UNITED STATES PATENT AND TRADEMARK OFFICE

APPLICATION NO.	FILING DATE	FIRST NAMED INVENTOR	ATTORNEY DOCKET NO.	CONFIRMATION NO.
10/015,847	12/10/2001	Theodore J. Letavic	US 010610	3619

Office Action Summary

DETAILED ACTION

FIG. 2
RELATED ART

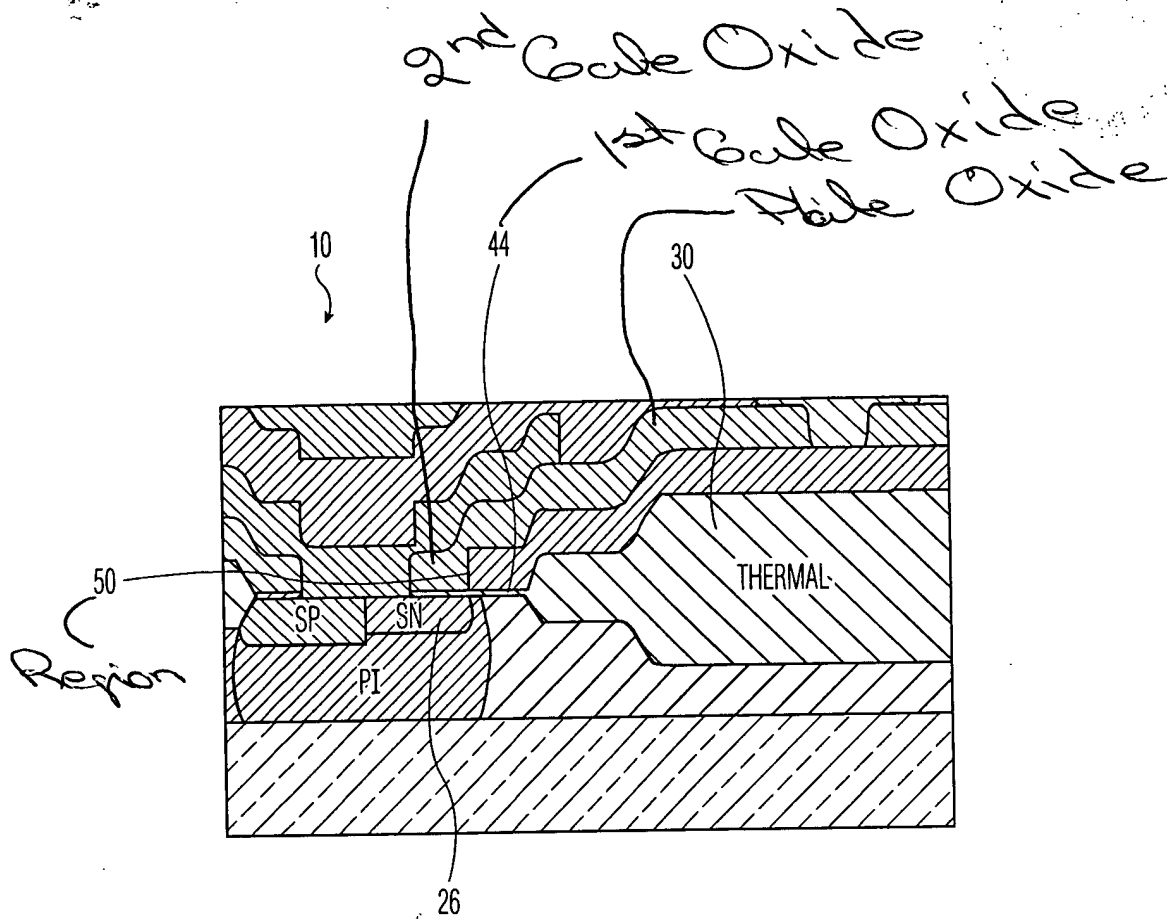
However, Applicant's Related Art discloses a second gate oxide over a portion of the first gate oxide (For Example: See Figure 2). It would have been obvious to one having ordinary skill in the art at the time the invention was made to modify the semiconductor device of Merchant to

However, Applicant's Related Art discloses a second gate oxide (For Example: See Figure 2). It would have been obvious to one having ordinary skill in the art at the time the invention was made to modify the semiconductor device of Merchant to include a second gate oxide as disclosed in Applicant's Related Art because it aids in increasing the breakdown voltage.

However, Applicant's Related Art discloses a second gate oxide (For Example: See Figure 2). It would have been obvious to one having ordinary skill in the art at the time the invention was made to modify the semiconductor device of Merchant to include a second gate oxide as disclosed in Applicant's Related Art because it aids in increasing the breakdown voltage.

However, Applicant's Related Art discloses a second gate oxide (For Example: See Figure 2). It would have been obvious to one having ordinary skill in the art at the time the invention was made to modify the semiconductor device of Merchant to include a second gate oxide as disclosed in Applicant's Related Art because it aids in increasing breakdown voltage.

6. Applicant's arguments filed March 5, 2003 have been fully considered but they are not persuasive. Applicant argues that the “Office has misinterpreted Applicant’s Related Art, and that the cited combination of references fail to teach or suggest a second gate oxide formed over a portion of the first gate oxide.” However, Applicant’s Prior Art does disclose a second gate oxide formed over a first oxide (For Example: See Figure 2). The Examiner has attached marked up figures of the prior art and present invention to illustrate where the gate oxides are located (For Example: See Figure 2, Figure 3 and Column 6 Lines 12-23 and Column 7 Lines 1-2).
